| Project                      | <b>IEEE 802.16 Broadband Wireless Access Working Group</b> < <a href="http://ieee802.org/16">http://ieee802.org/16</a> >   |  |
| Title                        | <b>Rotated Codebooks for Closed-loop MIMO</b>  |  |
| Date Submitted               | <b>2004-05-04</b>  |  |

## Rotated Codebooks for Closed-loop MIMO

Fig 1. BER/FER Performance for Codebook based CL-MIMO w/o Rotation Matrix R

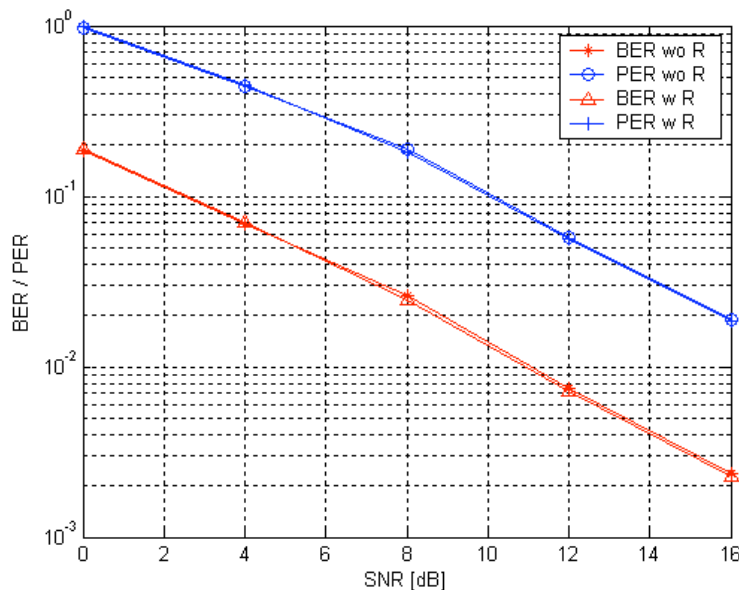
Fig. 1 shows the long term BER/FER performance for codebook based closed-loop MIMO system with different vector codebooks mentioned above. As can be seen, there is no performance difference at all. In addition, all transmit antenna will be used for every channel use.
